**Re: ODOARDI – Vacant Lot
22 Nethermont Ave. – New House Construction
Tax ID: Section 122.16 – Block 4 – Lot 7**

This letter accompanies a response to comments and revisions to plans, in response to the comments received from the Planning Board Staff and Town Consulting Engineer.

Re: **Site Plan Approval**

G.E.S Revisions/Written Response to Comments addressing the Planning Board Staff Report, dated January 24, 2020, and Revisions/Written Response to Comments Received from Kellard Sessions (Town Consulting Engineer), dated January 24, 2020.

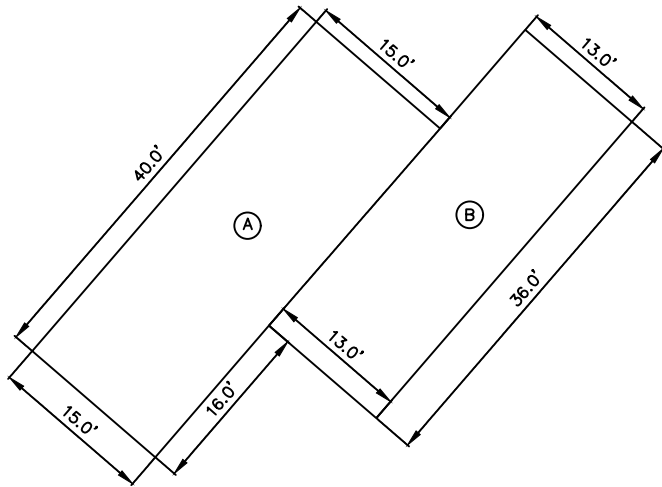
10. The Applicant should submit the required Gross Floor Area Calculations Worksheet and backup data for review.
 - Gross Floor Area Worksheet has been attached.
11. The Applicant should submit the required Gross Land Coverage Calculations Worksheet and backup data for review.
 - Gross Land Coverage Worksheet has been attached.
12. The site plan depicts the installation of a fence along the northern property line. A fence detail should be submitted for review.
 - Detail of Fence has been added to SWEC Detail Sheet.

LANDSCAPE PLAN

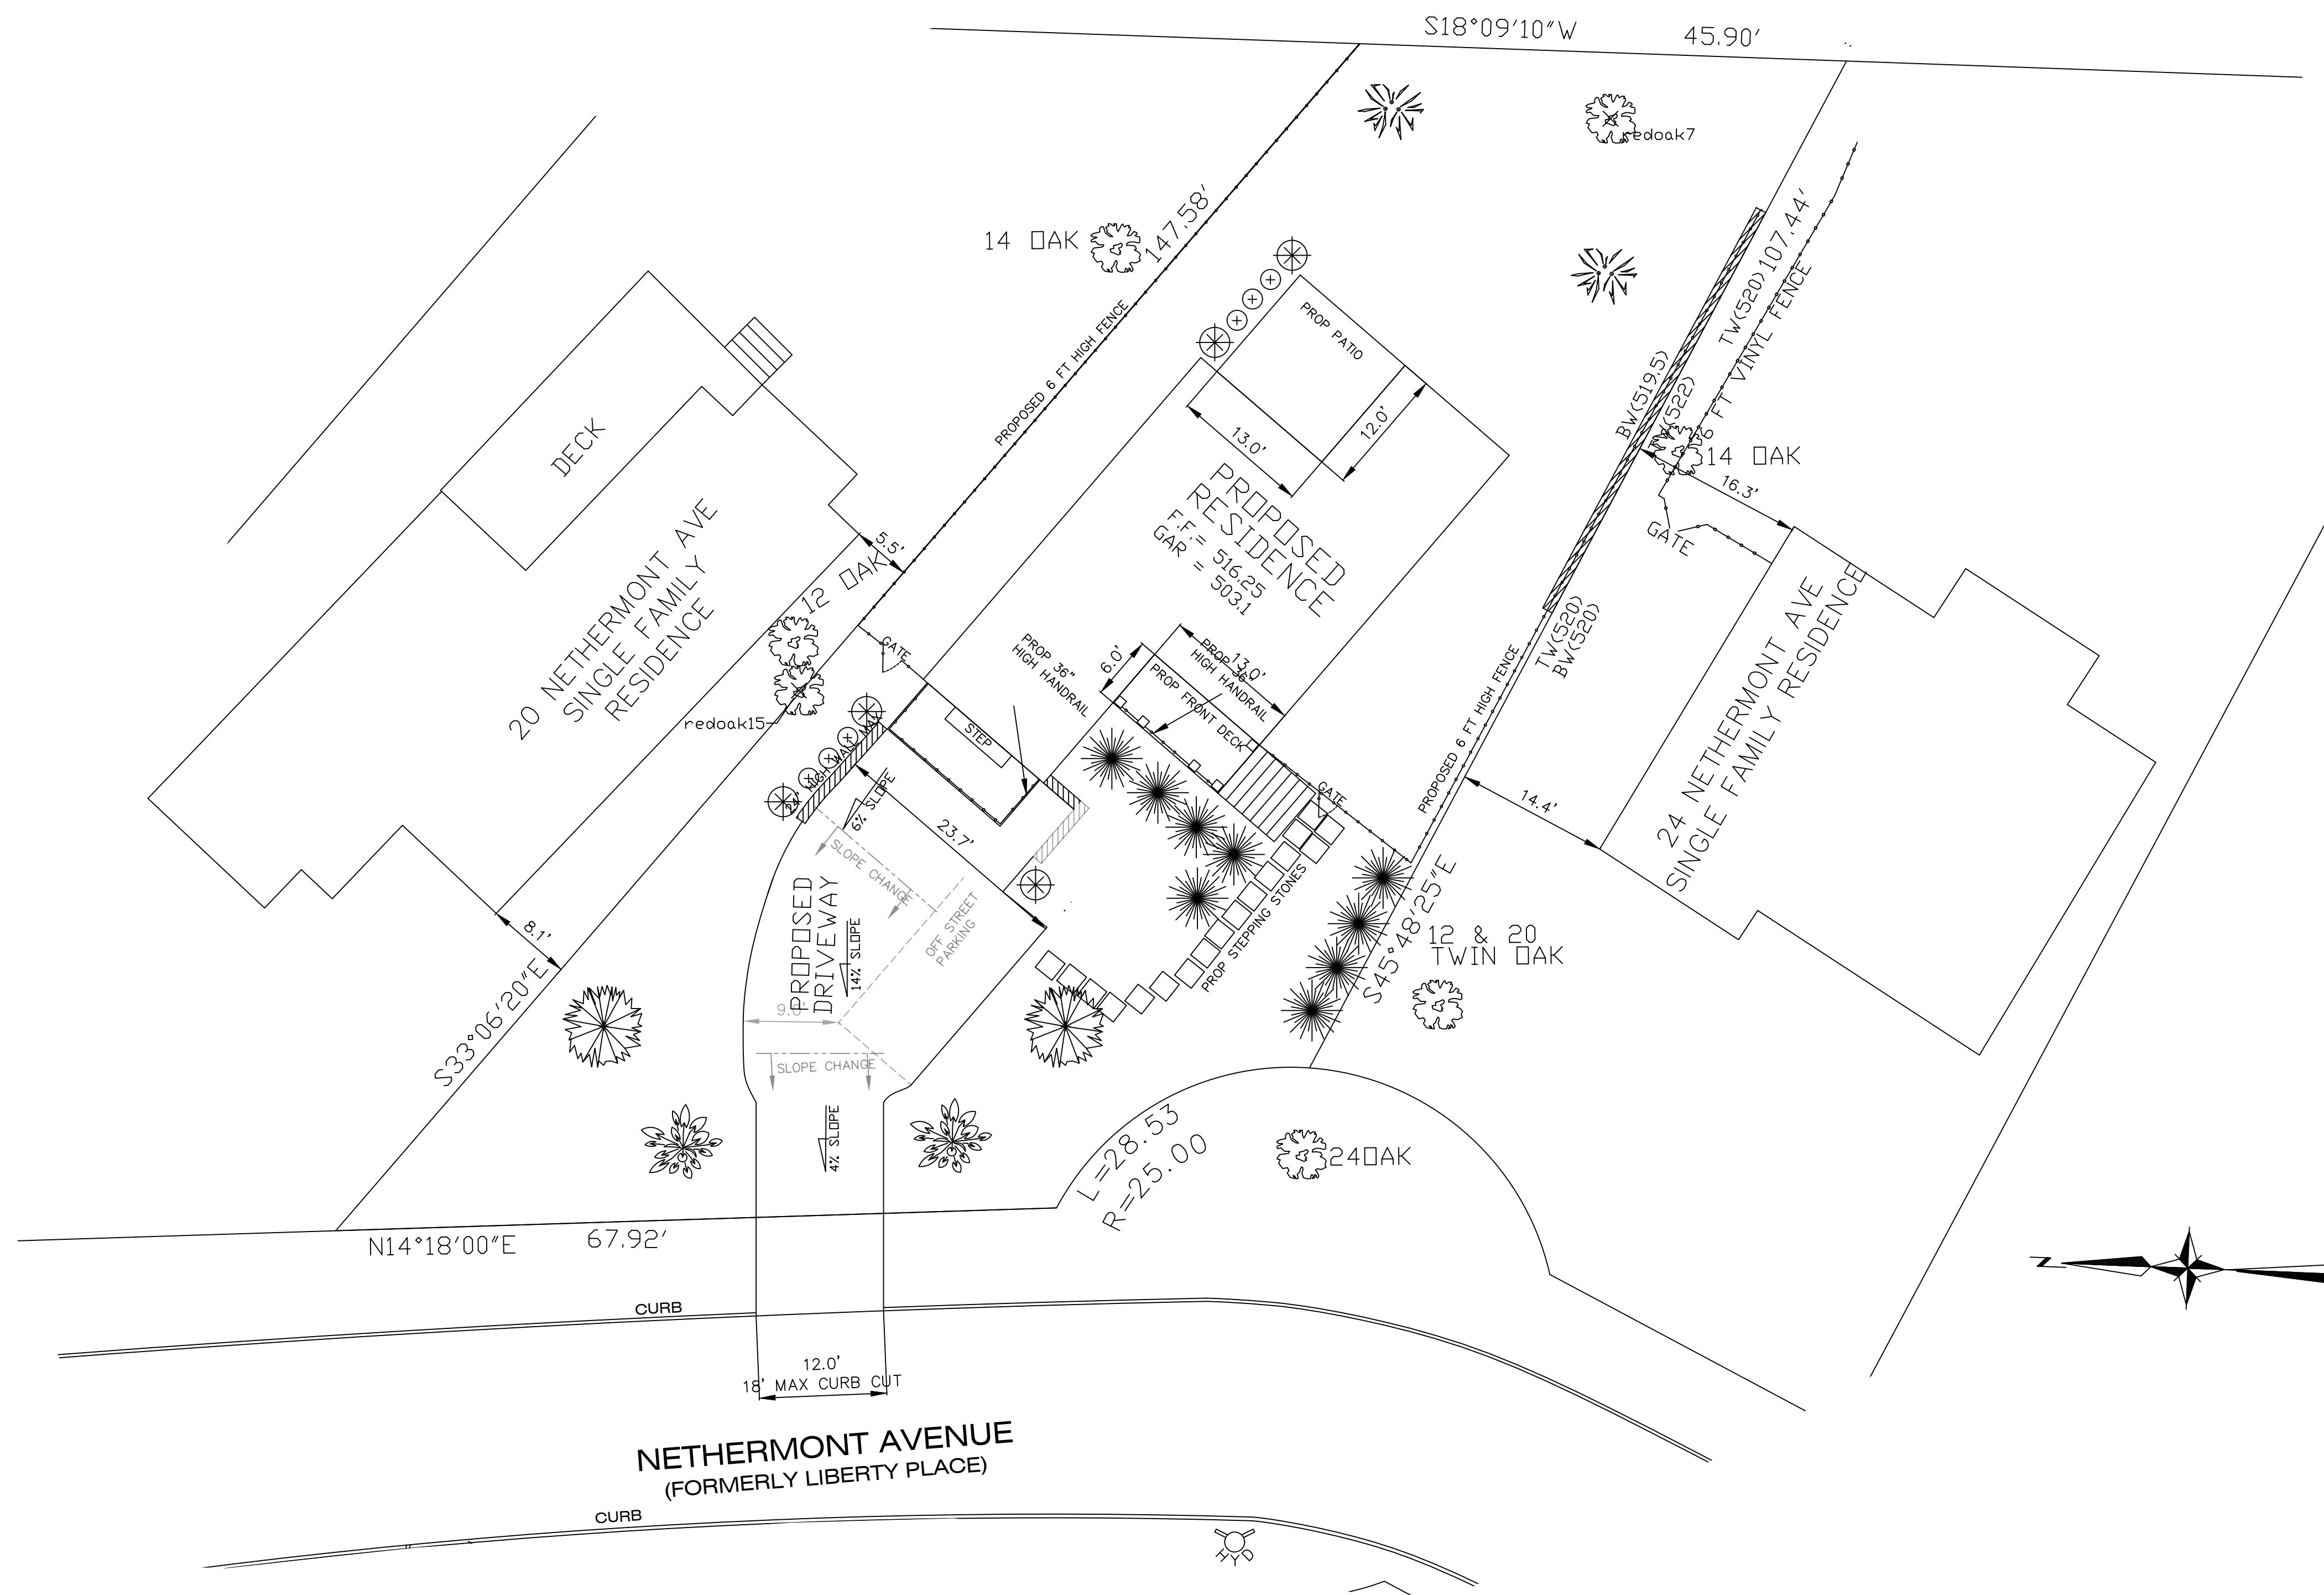
- All walls in excess of 6 ft have been removed.
6. The site plan depicts the removal of 12 (all but one) Town-regulated trees. *(Staff Notes: Pursuant to Section 308-15 of the Town Code the Applicant should submit a tree survey indicating the size, species and condition of the trees on the property. In addition, the Applicant should provide a plan that details the replacement proposed to mitigate the impacts from the proposed tree removal. It is recommended that additional planting be provided along the side lot lines.)*

6. As proposed, the development of the site requires clearing the site and the removal of fourteen (14) trees. A landscaping plan has been submitted for the Board's consideration. The Board should consider whether the amount of tree removal is appropriate and if additional screening is needed between the proposed house and neighboring properties.

- A tree survey (Sheet TS-1), arborist table/letter (Table on sheet TS-1 and Letter Included in Submittal), and replacement tree plantings (Sheet LS-1) have all been provided.

22 NETHERMONT
 PRE DEVELOPED AREAS USED IN
 CALCULATIONS

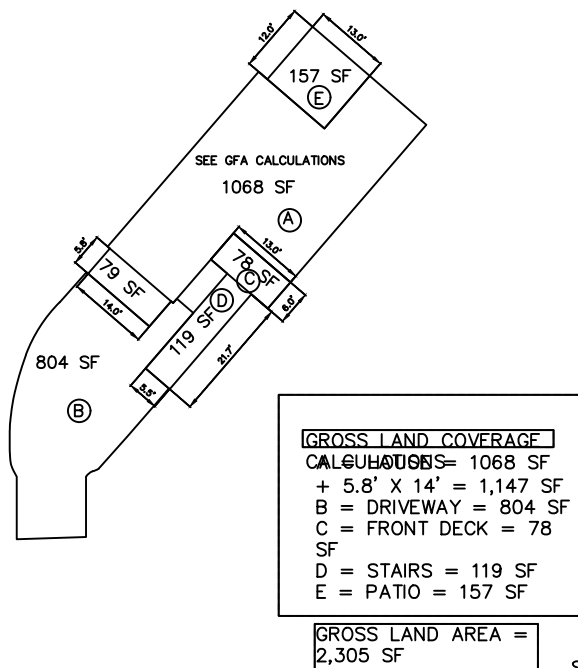
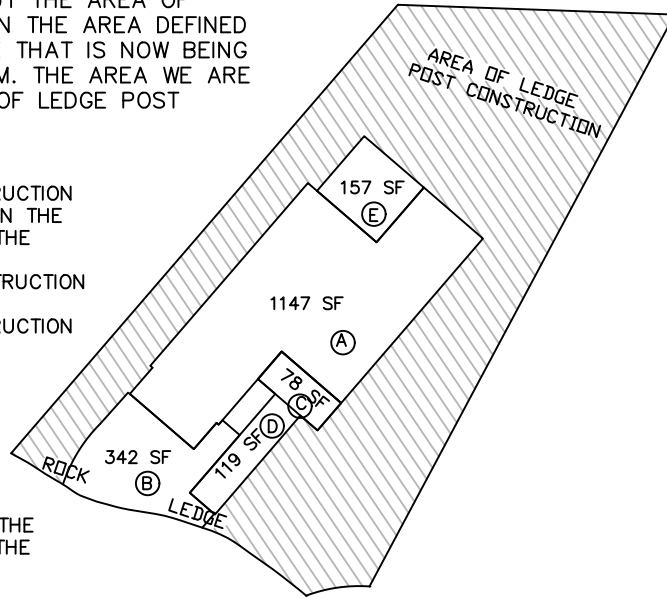
12. Provide stormwater mitigation and design calculations for the runoff generated by the net increase in impervious surfaces for the 100-year, 24-hour design storm event. All invert elevations of the stormwater detention system and outlet structures shall be coordinated between the plan, details and the calculations.

- Drainage areas associated with HydroCAD calculations has been attached to this submittal showing the areas used for pre and post calculations.
14. The proposed stormwater mitigation practice is located less than one (1) foot from the front property line. All stormwater practices shall be located a minimum of ten (10) feet from all property lines. The plans shall be revised accordingly.

SIGHT DISTANCE PROFILES

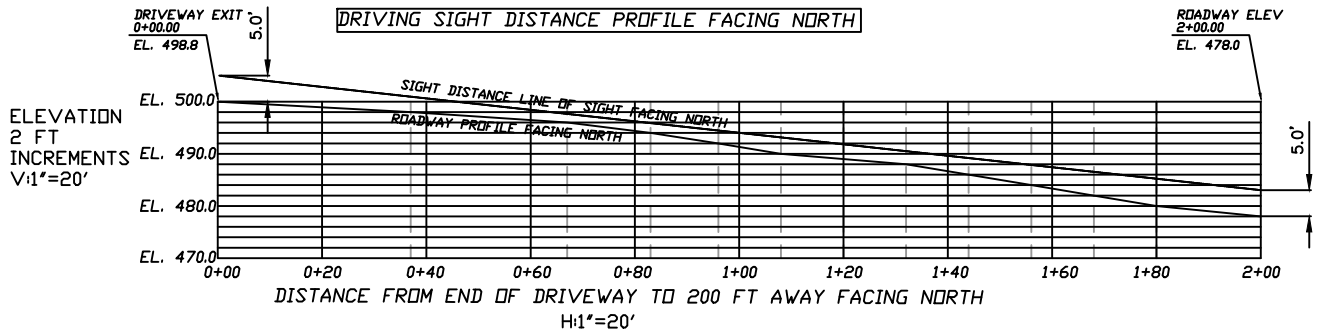
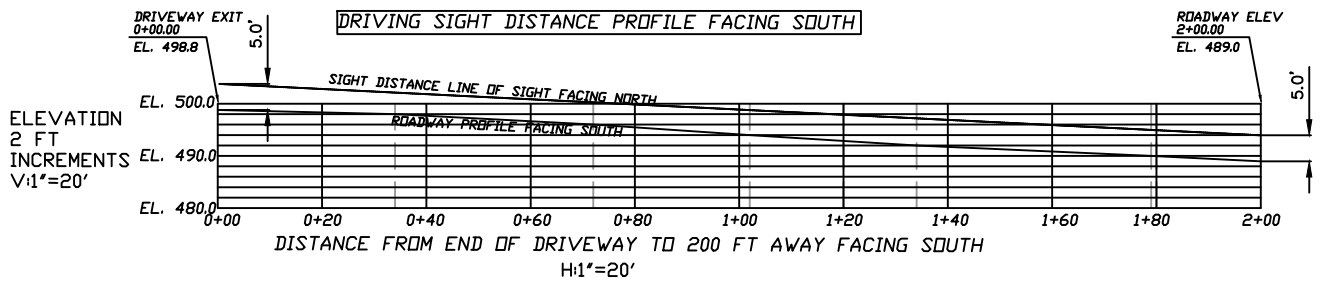
- N/A to Gabriel E Senior.
7. Sight distance profiles shall be provided to demonstrate that the required 200 foot minimum sight distance is achieved in both directions. Westchester County GIS topographic data may be used to obtain the required existing elevations for the road profile. The contour elevations should be in the same datum as the contours provided on the submitted plans.

- Applicant has addressed all outstanding staff and consultant comments.
8. The driveway profile shall be revised to include both horizontal and vertical scales, vertical curve data including high and low point elevations, length of vertical curve and existing and proposed station elevations. The profile shall be revised to demonstrate compliance with Sections 355-59 B (1) and (3) of the Town Code, related to maximum grades and limits of the 4% entry apron at the curb cut.
